RESOLUTION NO. 14-038

A RESOLUTION OF THE PLANNING COMMISSION OF THE CITY OF MILPITAS RECOMMENDING THE CITY COUNCIL DENY MAJOR TENTATIVE MAP NO. MT13-0007, SITE DEVELOPMENT PERMIT NO. SD13-0013 AND CONDITIONAL USE PERMIT NO. UP13-0013 FOR THE DEVELOPMENT OF 603 RESIDENTIAL UNITS AND 55,421 SQUARE FEET OF COMMERCIAL-RETAIL SPACE LOCATED IN THE MCCANDLESS/CENTRE POINTE AND MONTAGUE CORRIDOR SUB-DISTRICTS OF THE TRANSIT AREA SPECIFIC PLAN ON APPROXIMATELY 15.68 ACRES

Figure 7
TASP Street Network for Centre Point

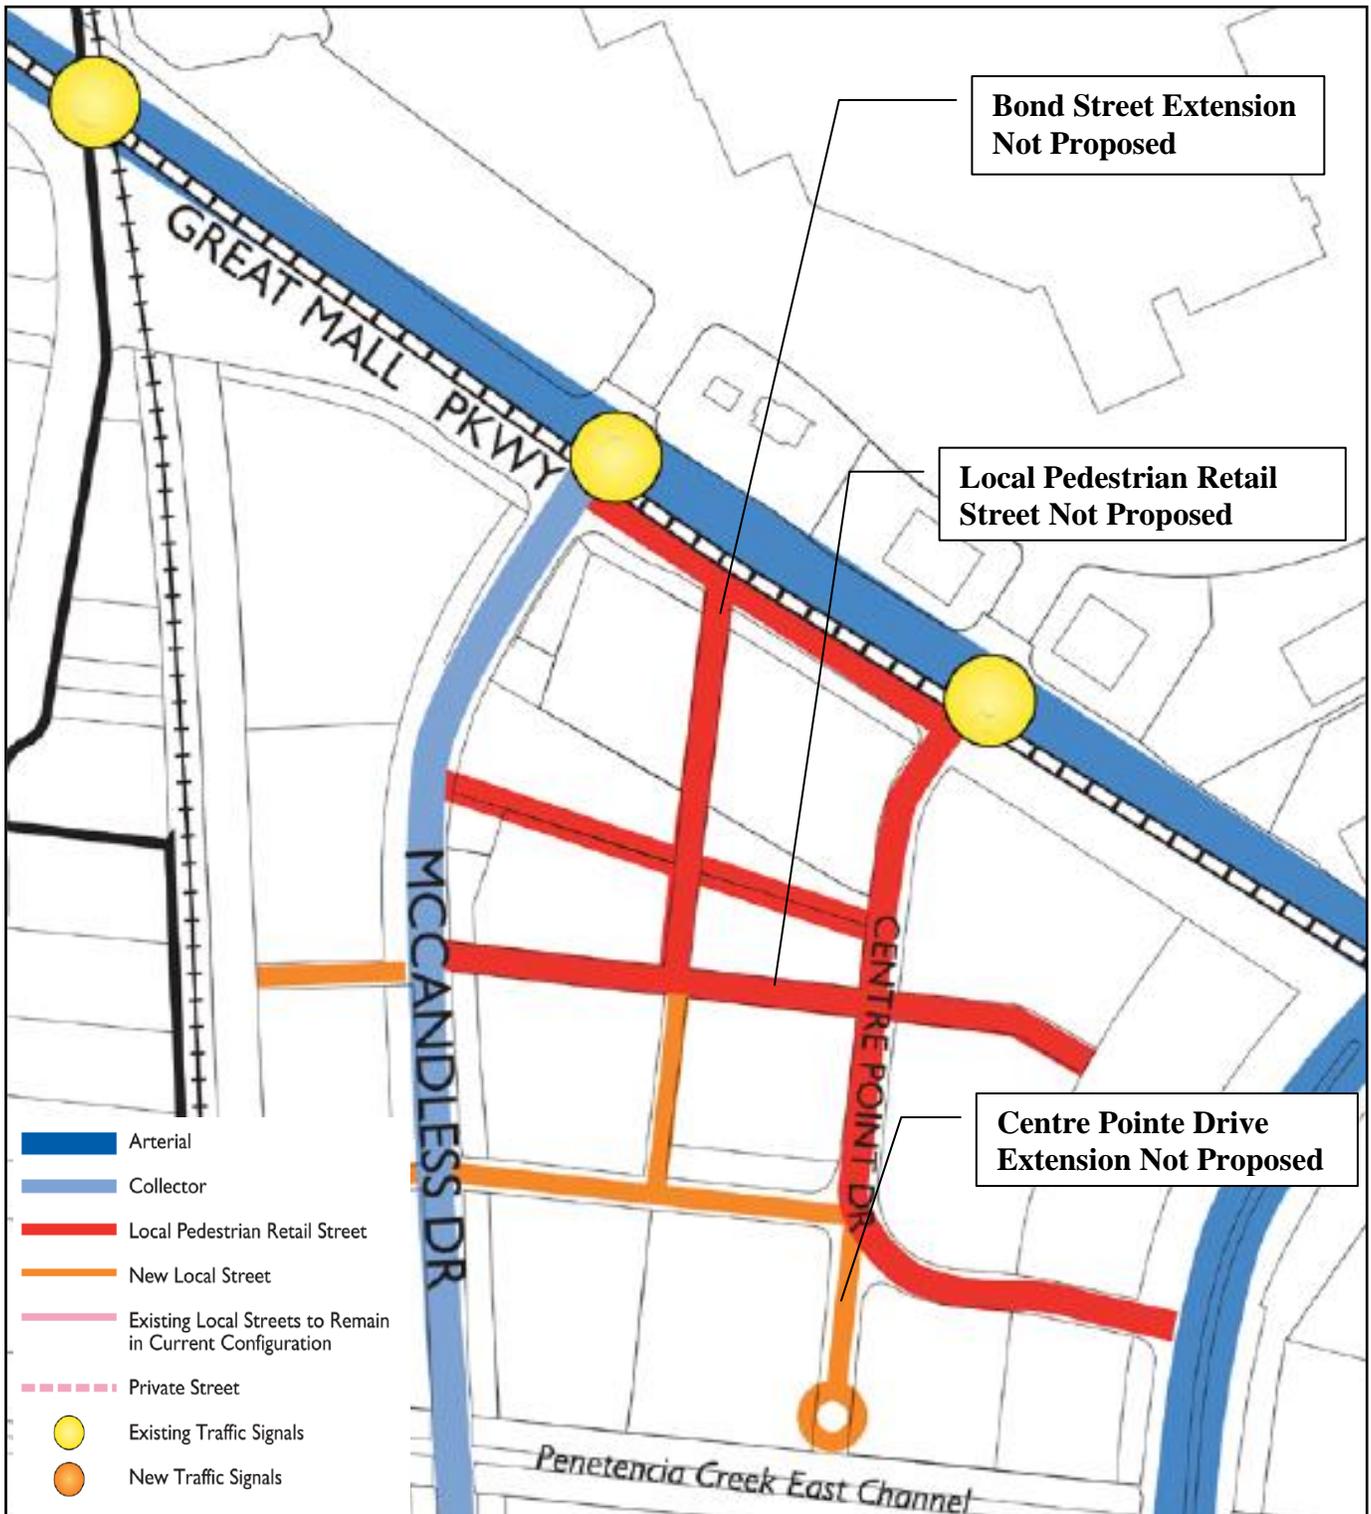
The proposed Project's circulation system is inconsistent with the TASP. Figure 7 illustrates the street network prescribed by the TASP. The inconsistencies with this network are summarized by street on the subsequent page.

The TASP illustrates Bond Street providing a connection to Great Mall Parkway. The proposed Project does not extend Bond Street to Great Mall Parkway and instead, Bond Street ends at a parking garage for Neighborhood A inconsistent with the TASP. TASP Policy 4.60 requires that block lengths do not exceed 450 feet, and encourages shorter block lengths of 300 to 400 feet. Bond Street measures approximately 610 feet from Newbury Street to Market Street. Therefore, Bond Street is inconsistent with the TASP street layout and block lengths.

The street layout and alignment for the proposed Centre Pointe Drive does not extend southward as planned for in the TASP. Additional analysis and studies are needed to determine the ultimate alignment and layout for this roadway and may be inconsistent with the TASP. Further, Centre Pointe Drive measures approximately 560 feet from Newbury Street to Market Street. This is inconsistent with TASP Policy 4.60 which requires block lengths not to exceed 450 feet.

The TASP Street Design and Character Plan illustrates a street bisecting the approximate location of Neighborhood B. The proposed Project does not incorporate this street. The TASP identified street is designed to be used as a pedestrian retail street. This proposed missing street further emphasizes the proposed Project's inconsistency with the TASP and the importance of providing mixed use development along a planned street frontage in Neighborhood B.
